TM 11-5820-398-35

RADIO SET AN/PRC-25

CHANGE }
No. 1 }

HEADQUARTERS
DEPARTMENT OF THE ARMY
WASHINGTON, D.C., 17 September 1964

Figure 13. Transmitter ipa module A6, schematic diagram.

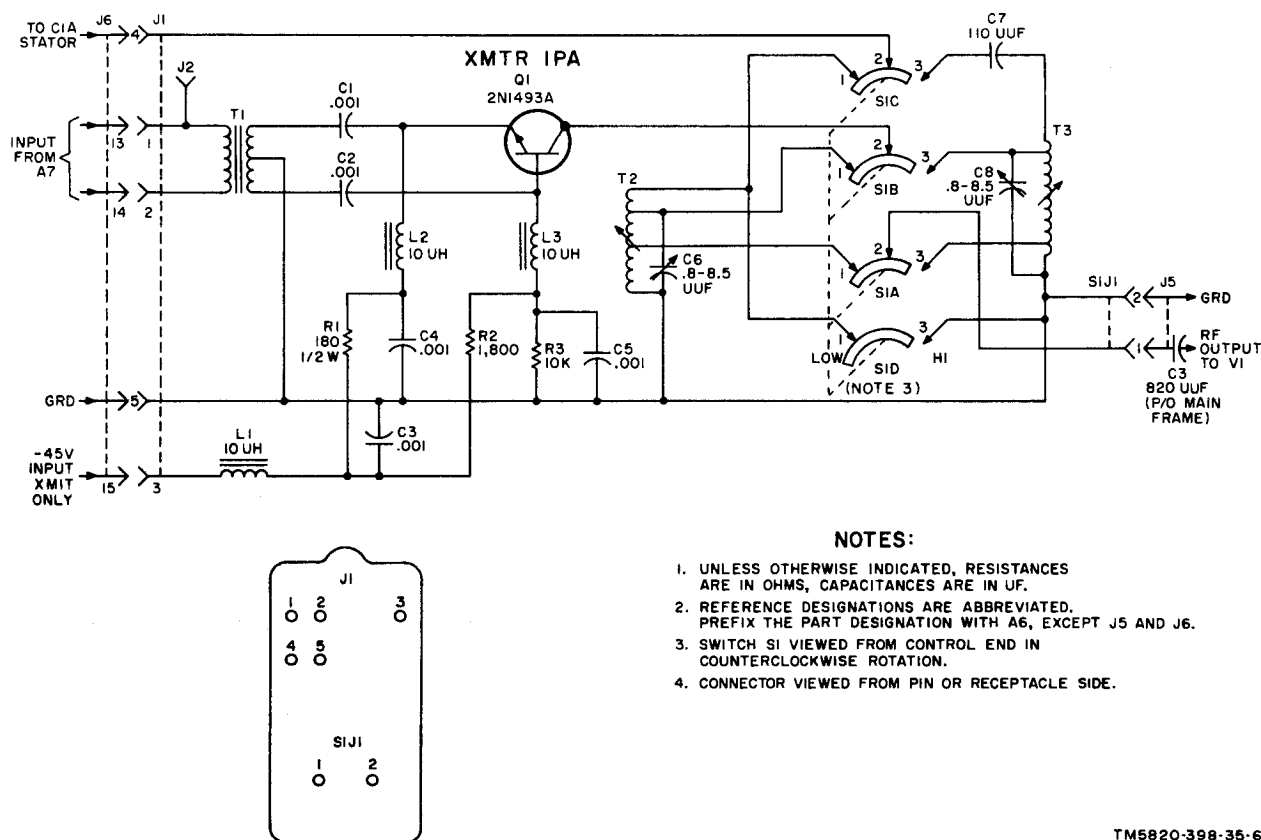
Page 24, figure 13. Add a 1,000-ohm resistor, R4, between pins 1 and 5 of J1.

Figure 18. 1-mc spectrum generator module A15, schematic diagram.

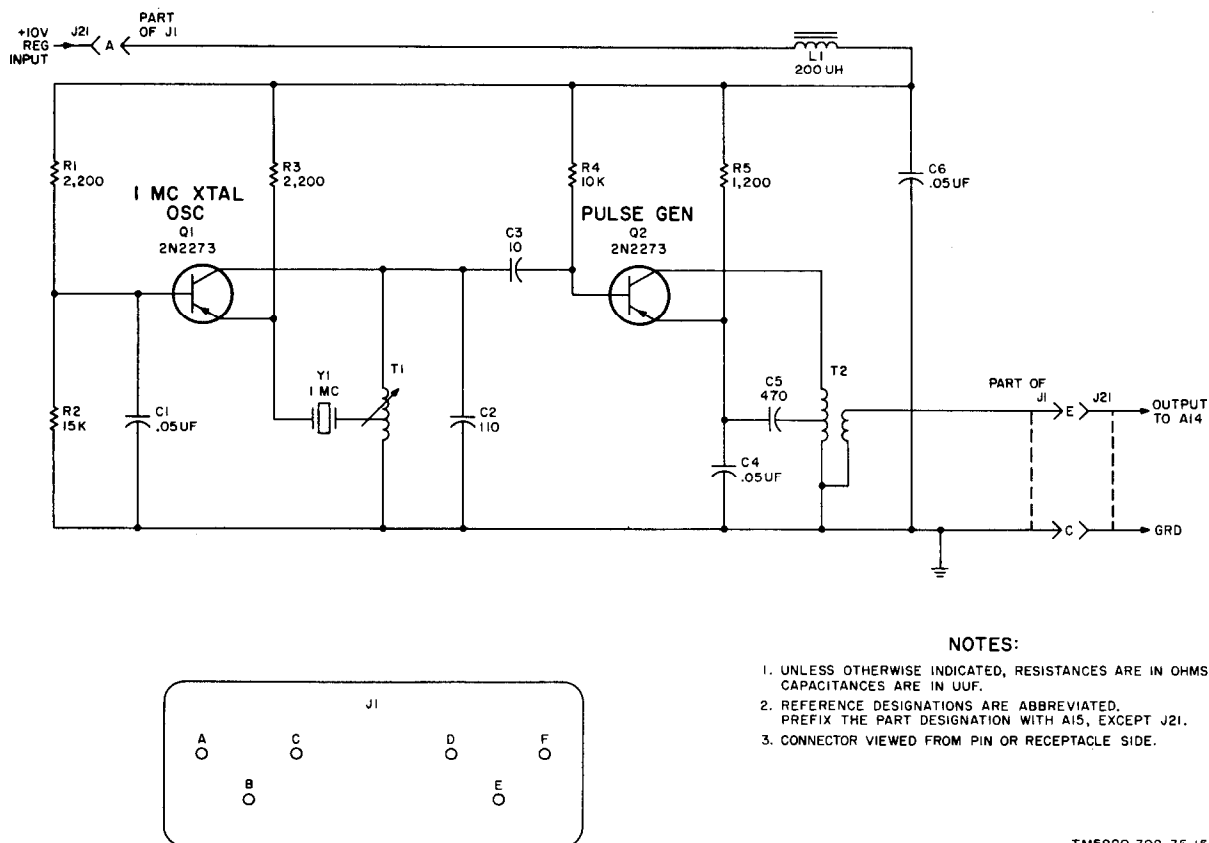
Page 27, figure 17. Make the following changes:

Near C4, add: (NOTE 4).

Figure 21. Second mixer module A12, schematic diagram.

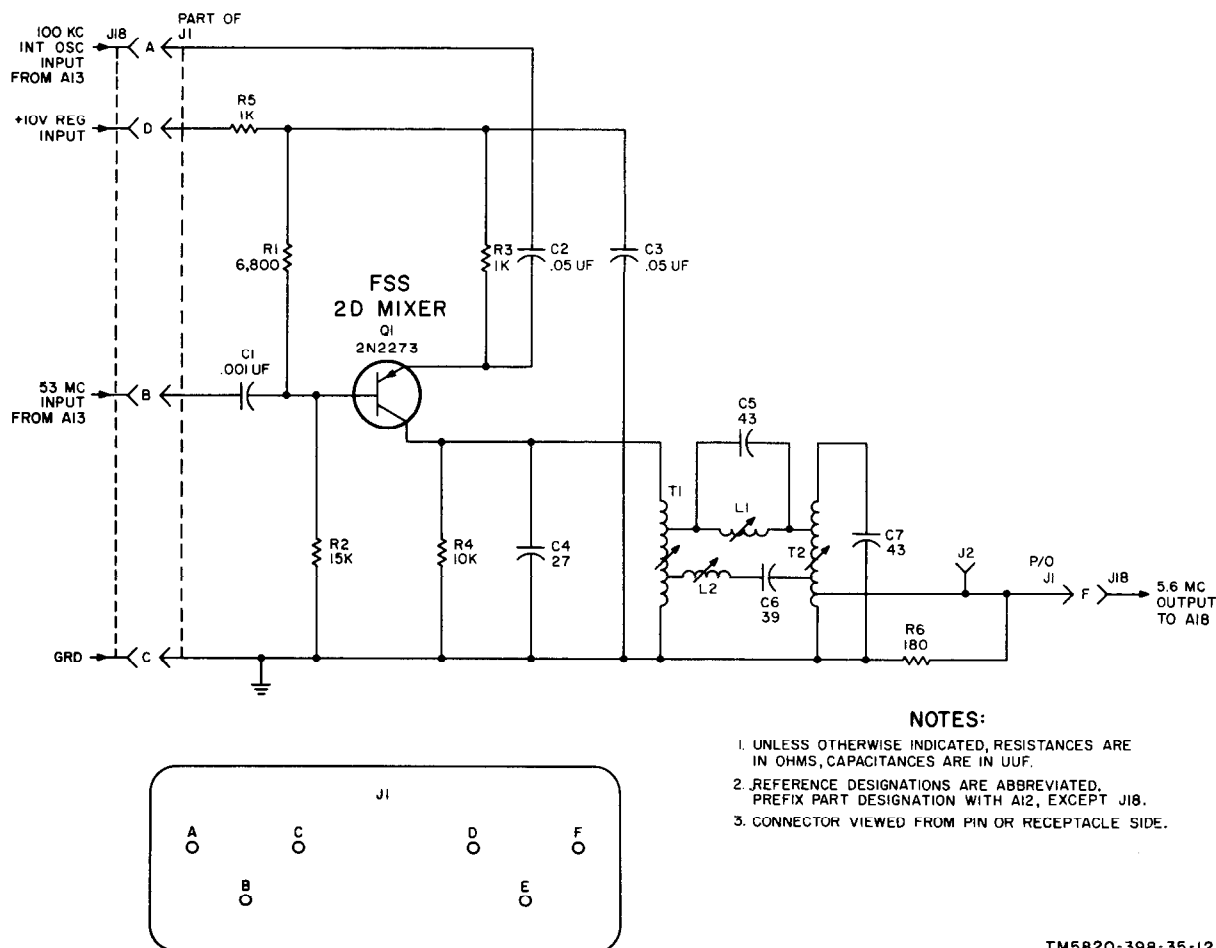
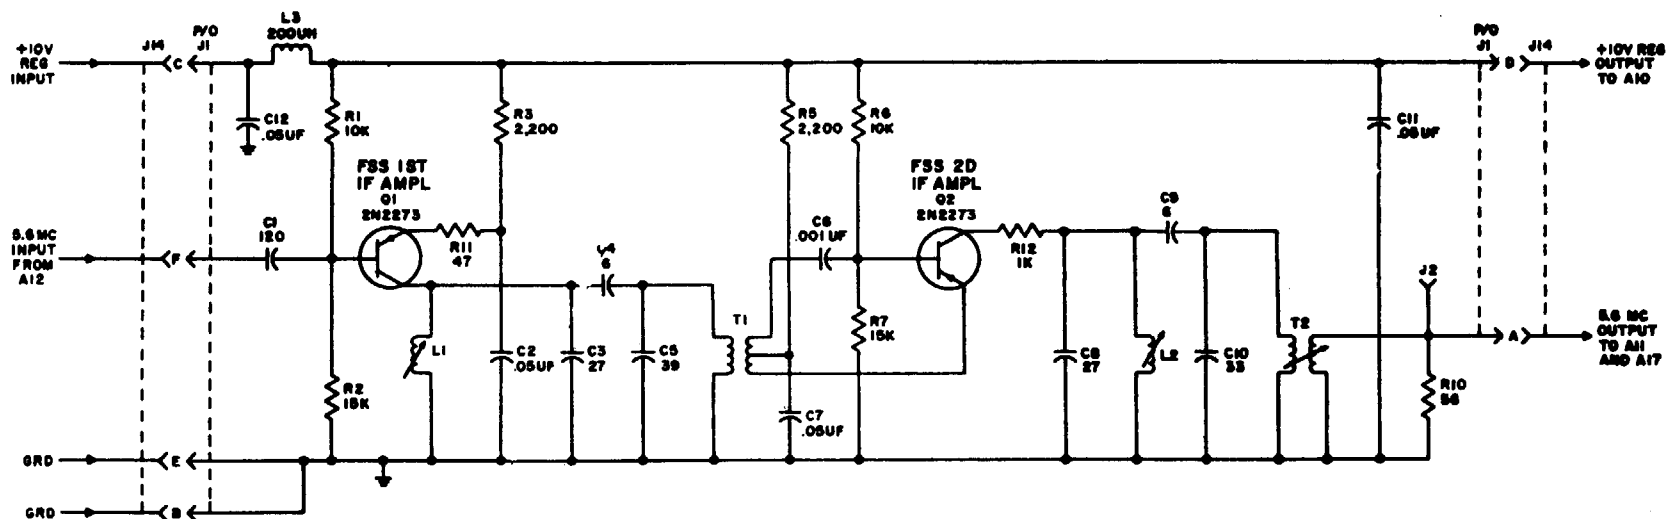
Figure 21. Make the following changes:

Near R4, add: (NOTE 4).

Near R6, add: (NOTE 5).

Figure 24. Fss discriminator module A11, schematic diagram.

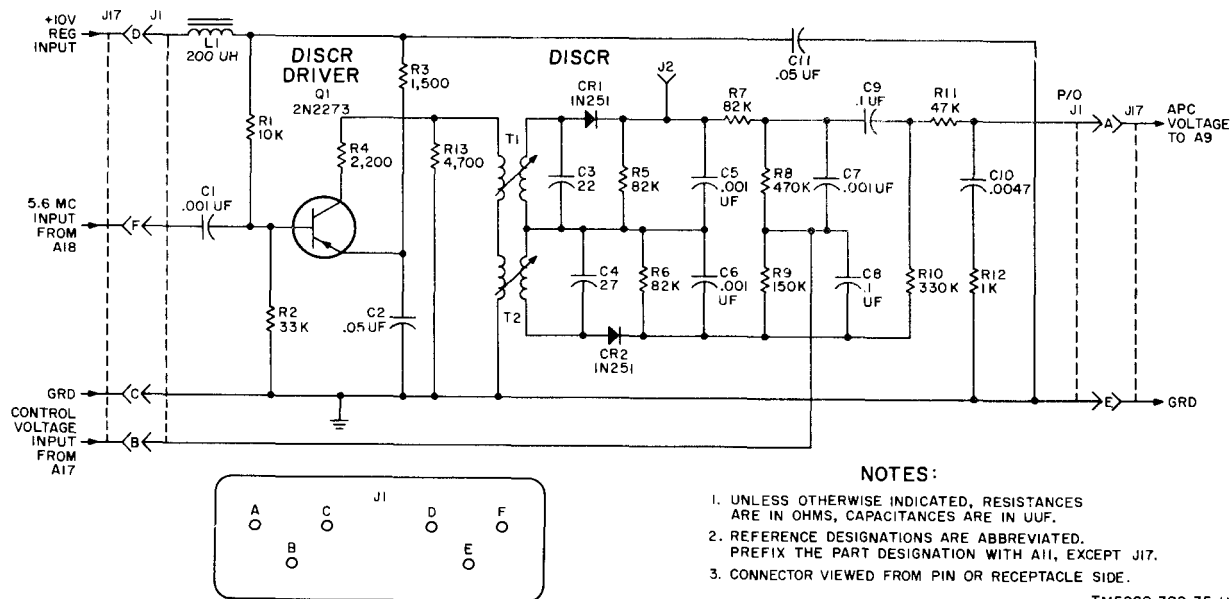
Page 37, figure 24. Make the following changes:

Delete R13.

Change the value of R5 from 82K ohms to 47K ohms.

Change the value of R7 from 82K ohms to 47K ohms.

Figure 25.1. Voltage regulator module A16, late model, schematic diagram.

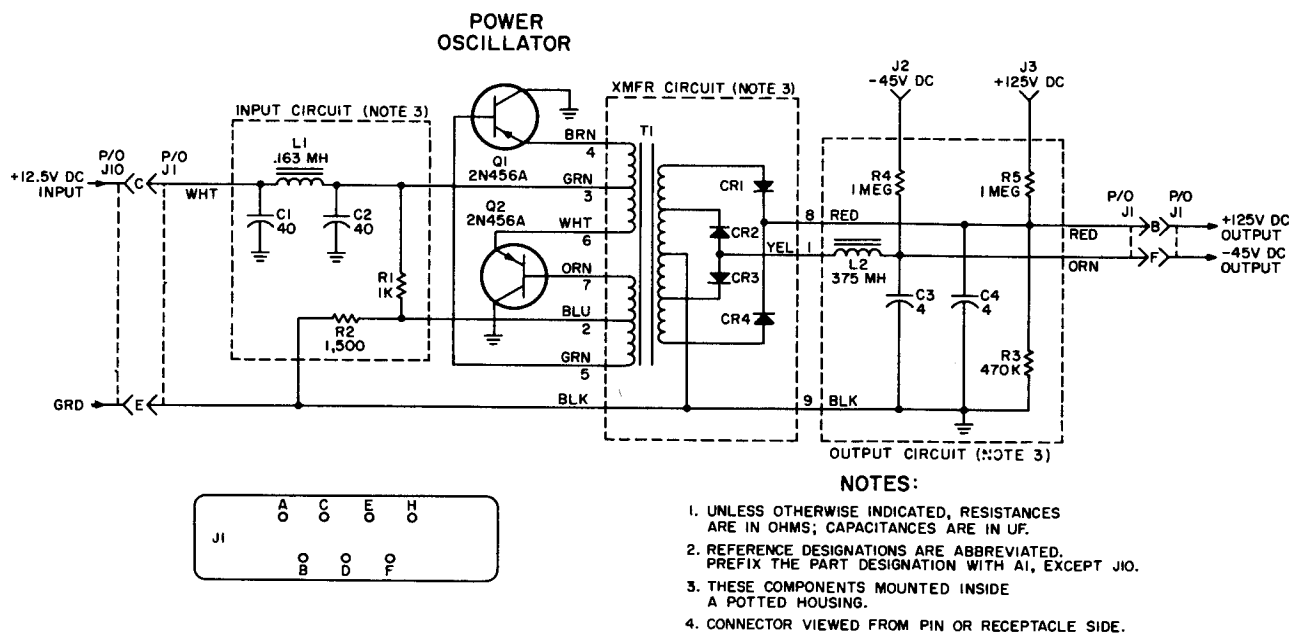
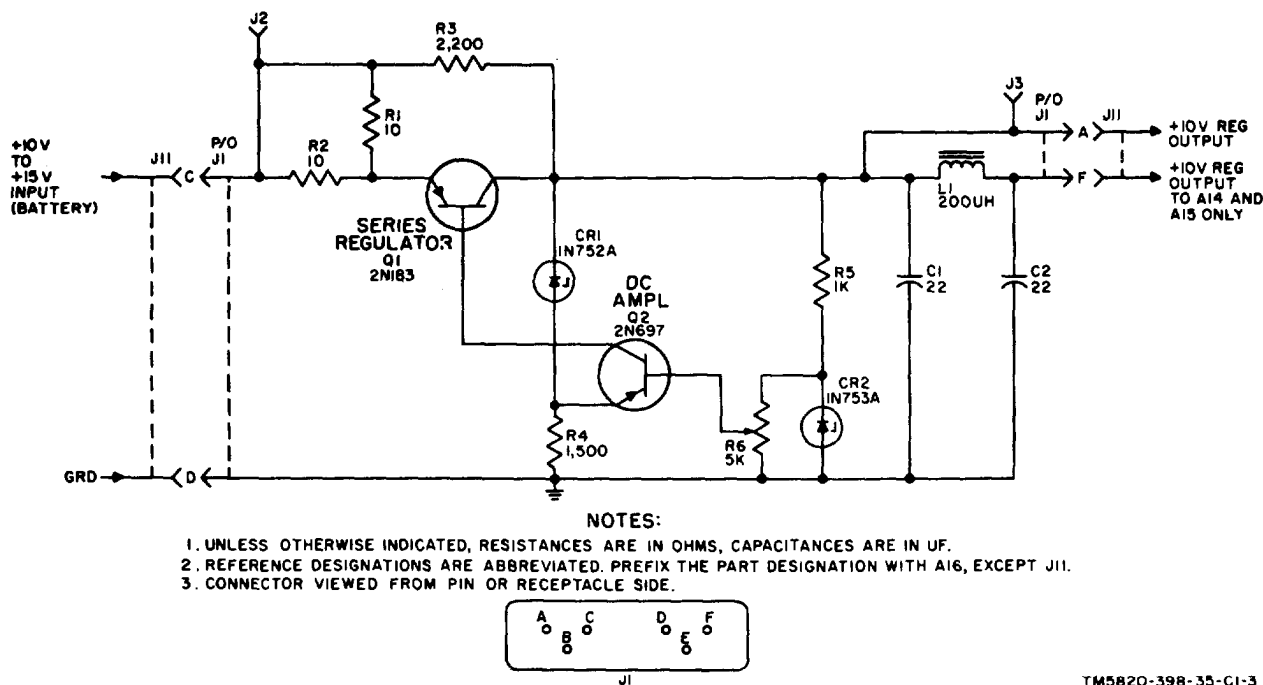
Paragraph 30. After the last sentence of the paragraph, add: In late models (fig. 25.1), potentiometer R6 is connected across CR2 to permit adjustment of the voltage applied to the base of Q2. This provides a fine adjustment of the regulated output voltage.

Page 38, figure 25. Change the figure caption to: Voltage regulator module A16, early model, schematic diagram.

Add figure 25.1 after figure 25.

Figure 85. Receiver if. amplifier module A21, schematic diagram.

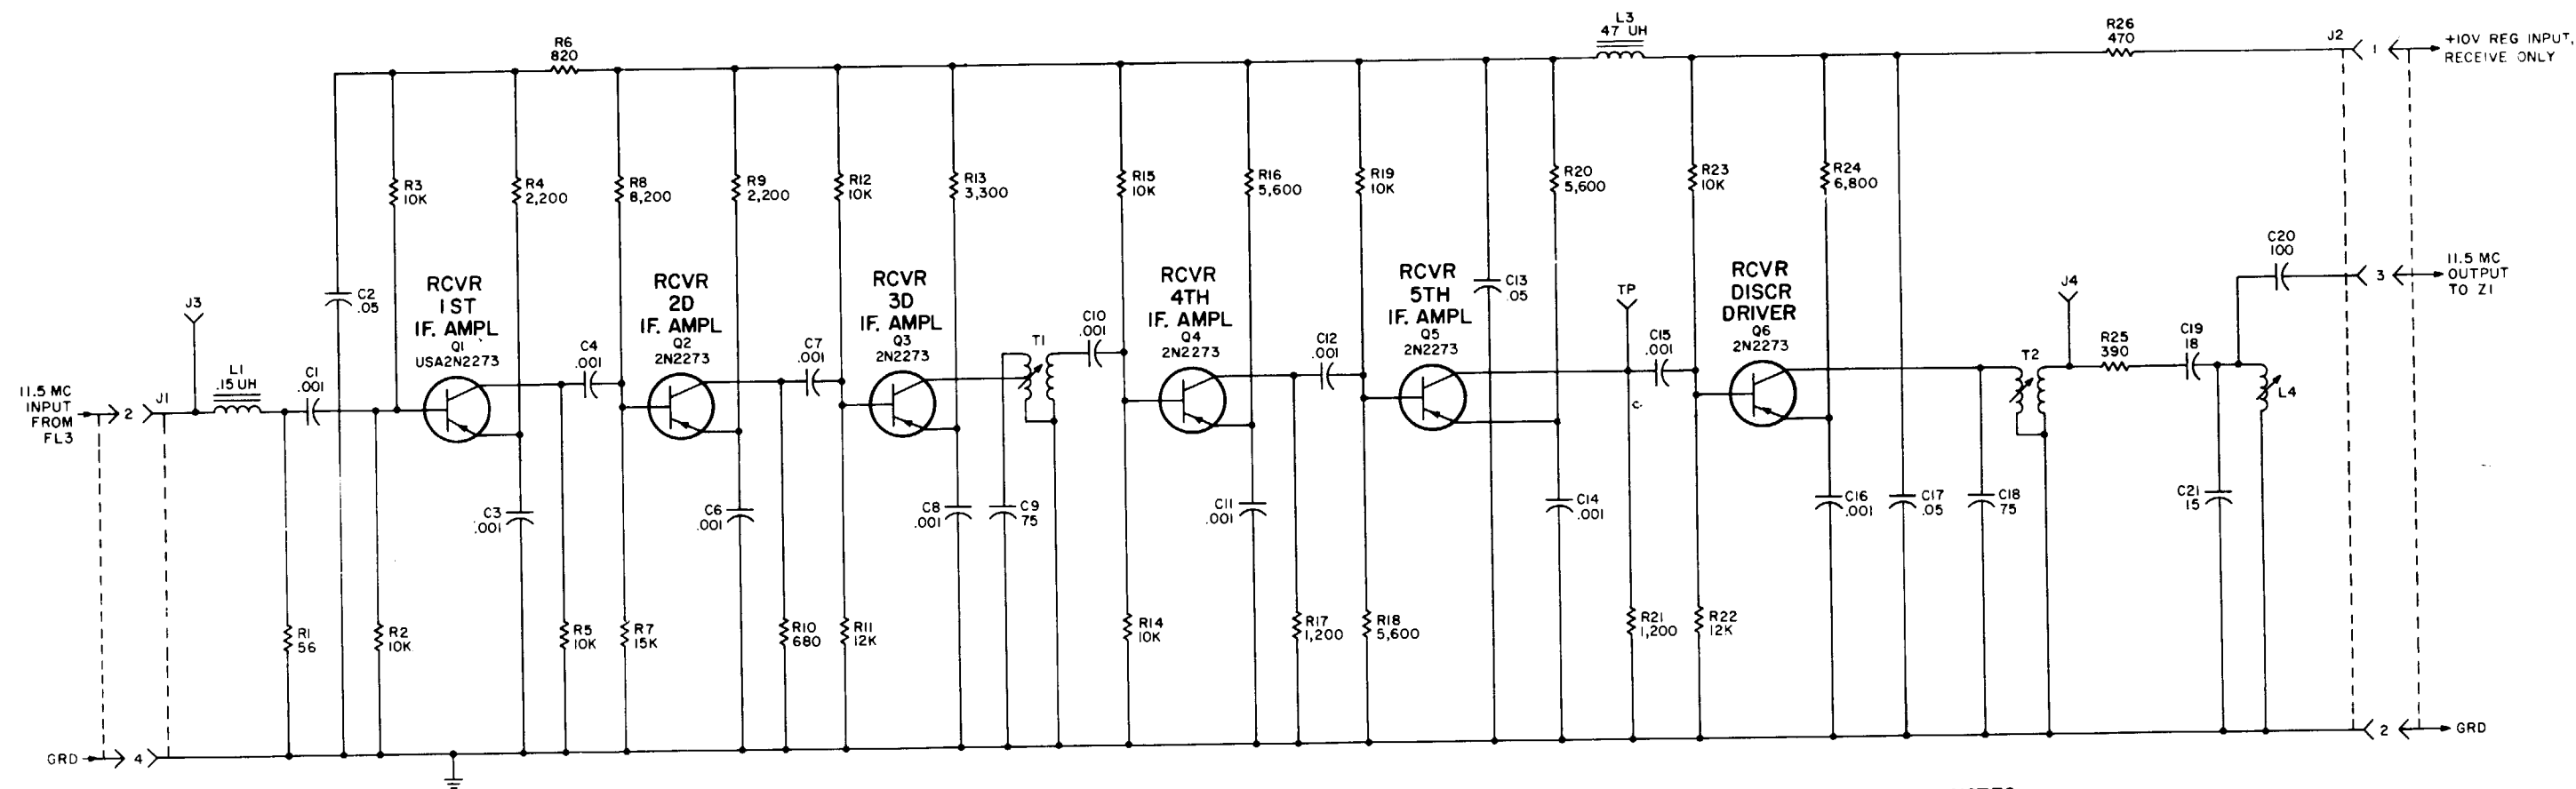
Page 161, figure 85. Make the following changes:

Near C21, add: (NOTE 4).

Figure 88. Receiver-Transmitter, Radio RT-505/PRC-25, overall schematic diagram.

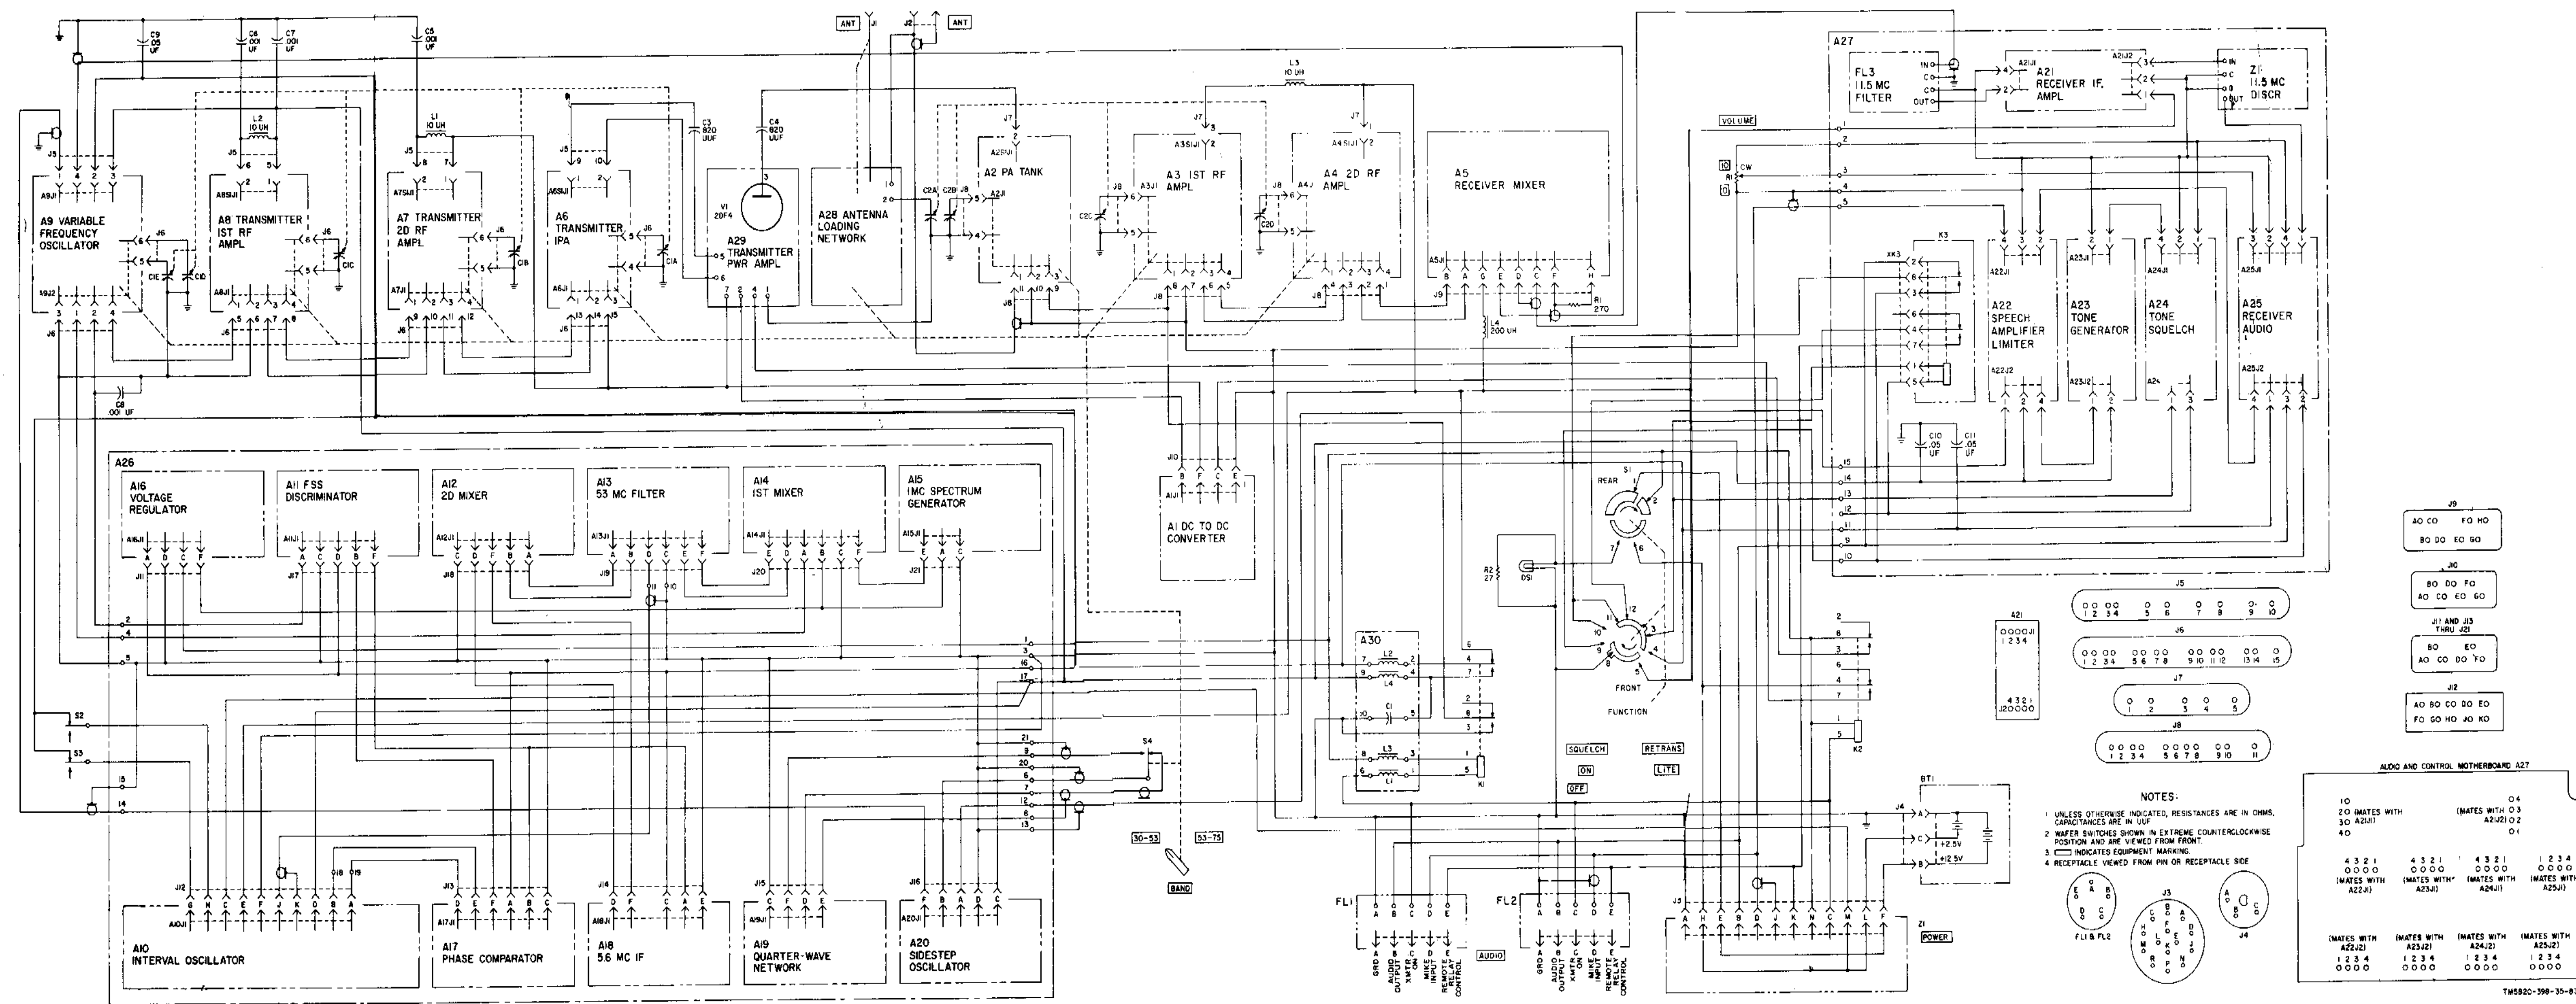
Page 167, figure 88. Make the following changes:

Near switches S2 and S3 add: (Note 5).
